REMARKS

This application has been reviewed in light of the Office Action dated January 10, 2003. Claims 1-3 and 5-27 are pending in this application, with Claims 1, 8, 16, 19, and 22 in independent form. Claim 4 has been cancelled, without prejudice or disclaimer of the subject matter presented therein. Claims 1, 8, 16, and 26 have been amended to define more clearly what Applicants regard as their invention. Applicants note that the changes to Claims 16 and 26 affect matters of form only and do not, in any way, narrow the scope of either of these claims. Favorable reconsideration is requested.

FIG. 15

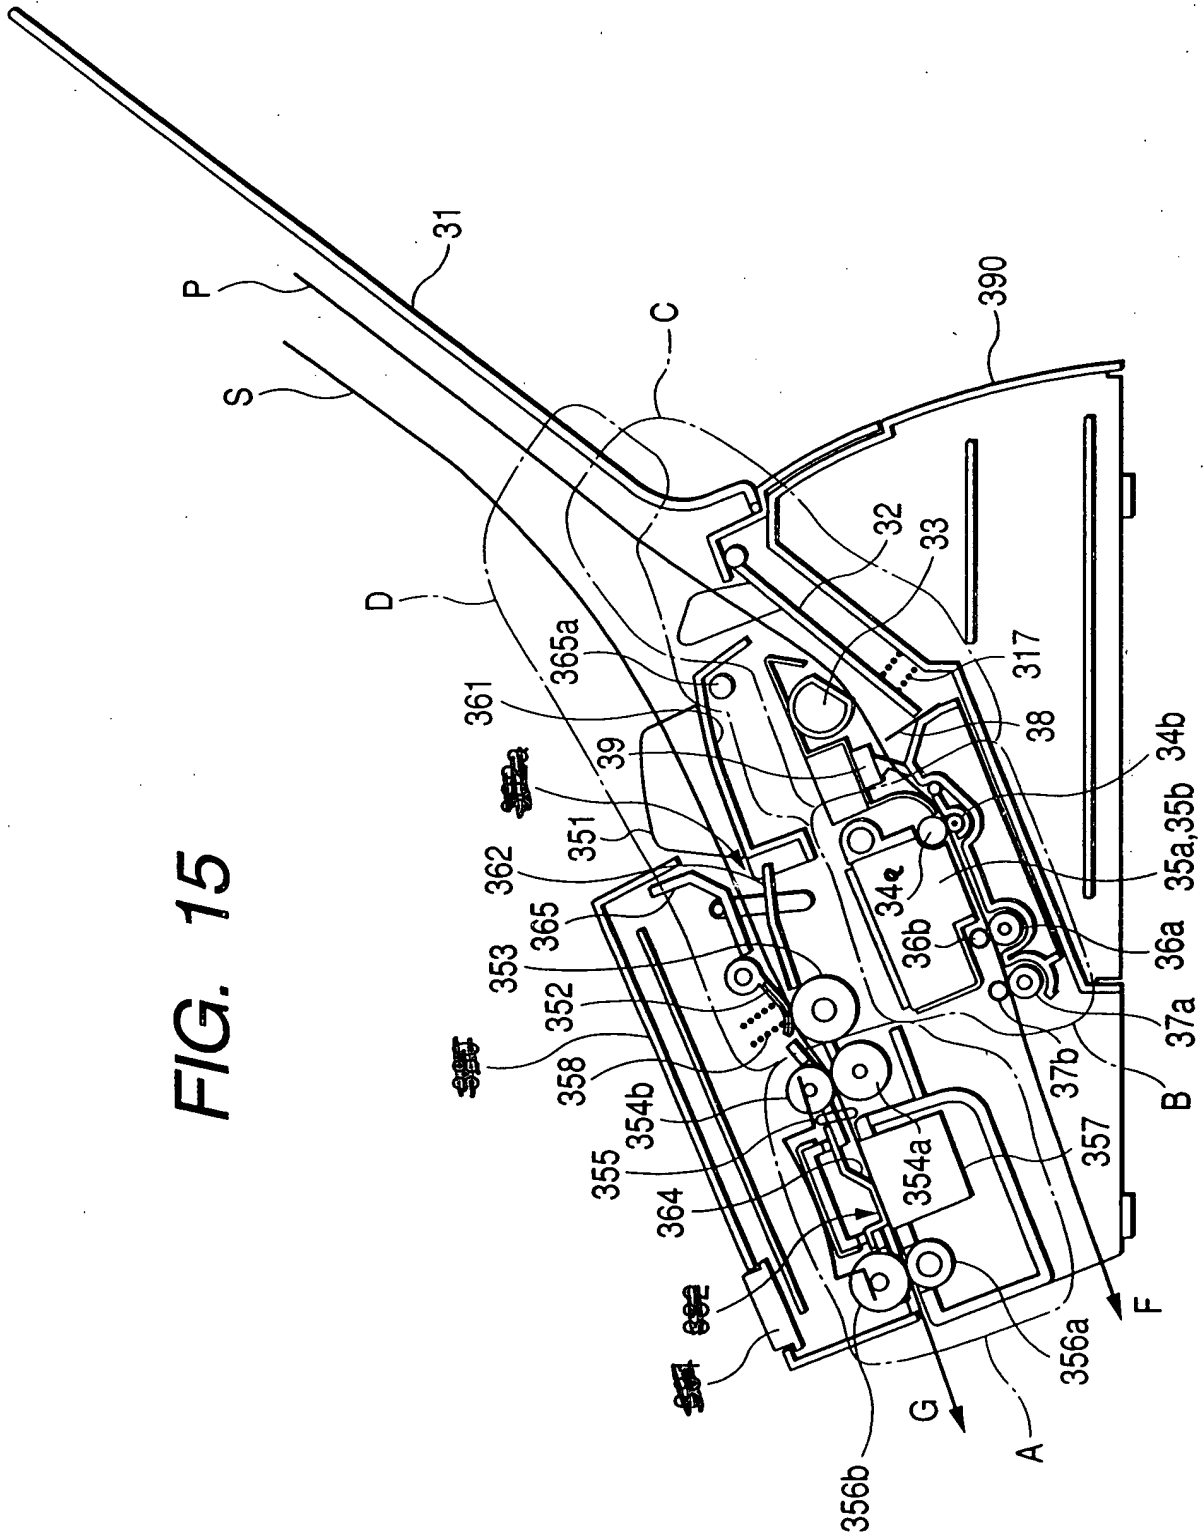
351: Figure 15, top

353: Figure 15, top

361: Figure 15, top

FIG. 37

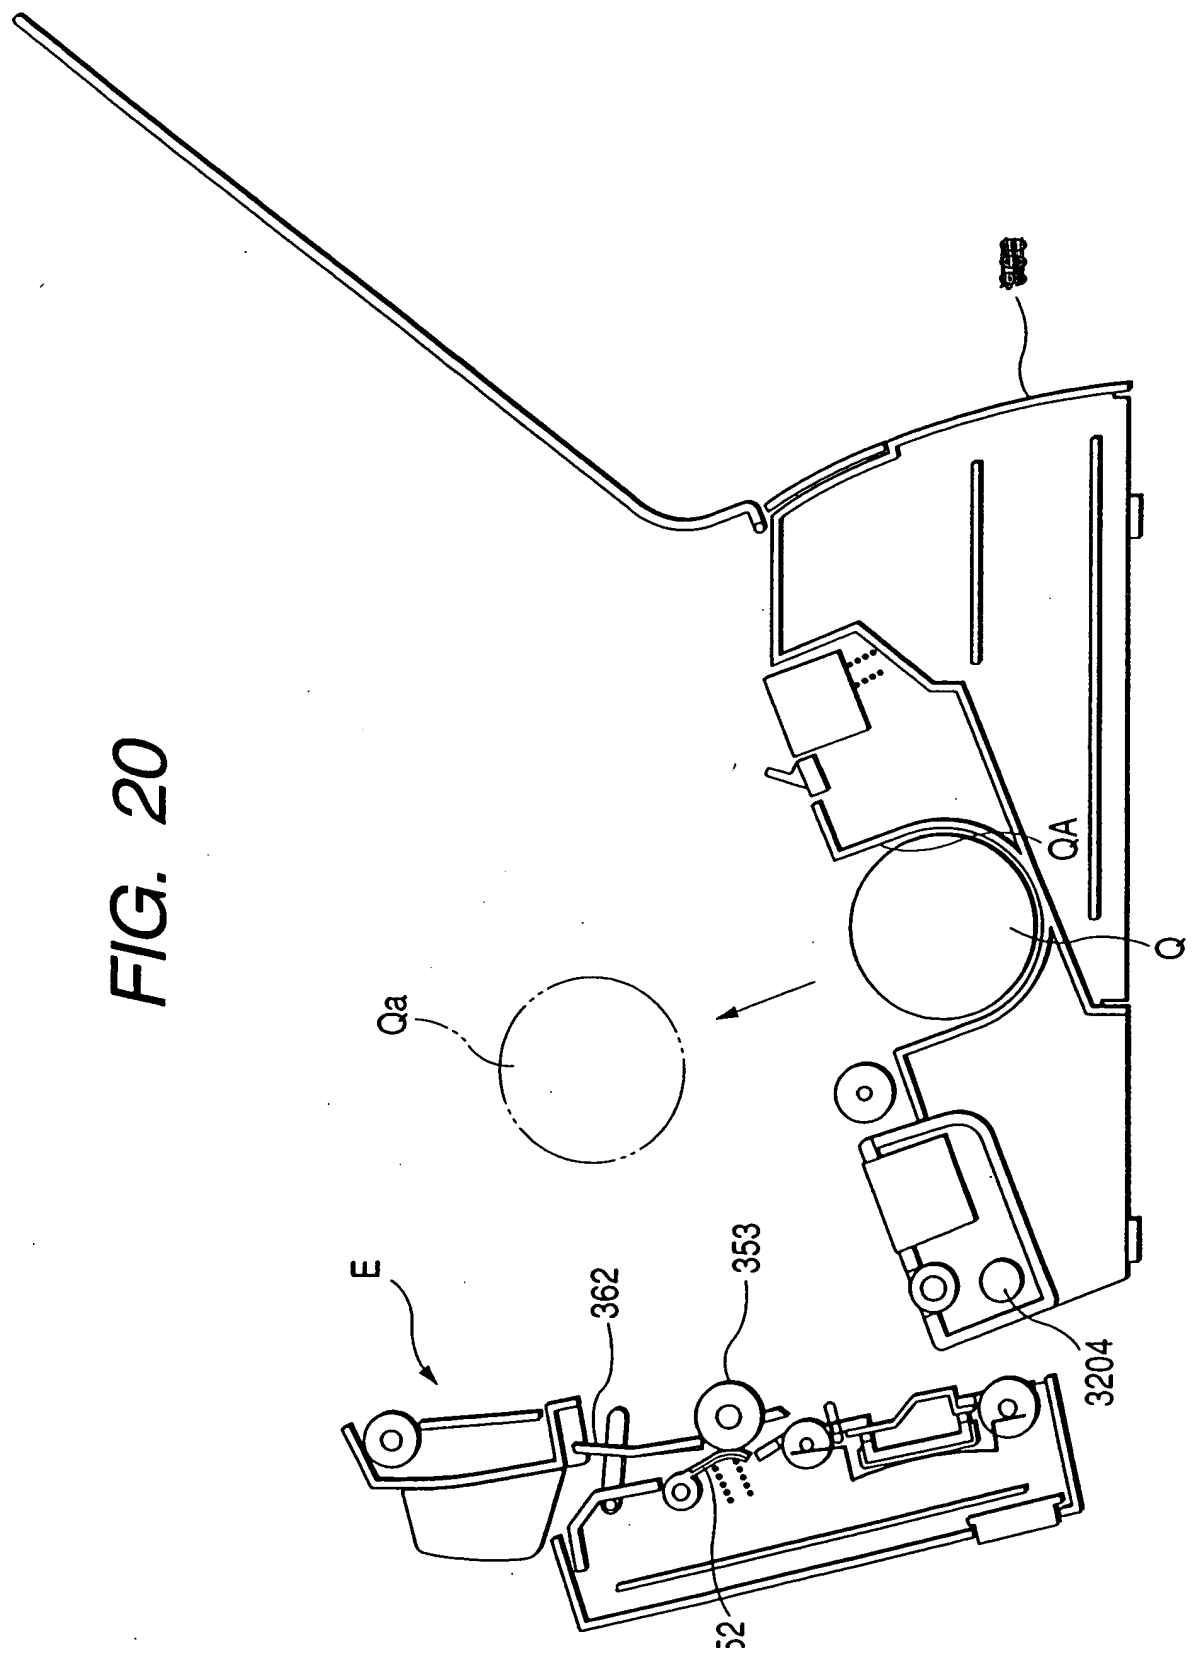
The Office Action also includes a set of objections to the drawings under 37 C.F.R. § 1.84(p)(5), for allegedly including reference numerals mentioned in the specification, but not shown in the drawings. With the exception of reference numerals 14, 21b, 428, and 1104a, all of the reference numerals, listed in the top half of paragraph 3 of the Office Action, were found in the figures. For reference numeral 14, Applicants have amended page 54, line 9 of the specification to read --the reading sensor 214--, instead of “a reading sensor 14.” Reading sensor 214 can be found in Figure 10. In regard to reference numeral 21b, Applicants have amended page 62, line 6, to read --feeding roller 211b--, instead of “feeding roller 21b.” Feeding roller 211b is shown in Figure 10. For reference numeral 428, Applicants have amended page 88, line 20, to read --Numeral 426 denotes a sensor for detecting the tip end of the recording sheet--, instead of “Numeral 428 denotes a sensor for detecting the tip end of the recording sheet.” Sensor 426 can be found in Figures 22 and 23. Finally, in regard to reference numeral 1104a, Applicants are amending Figure 37 to include this reference numeral.
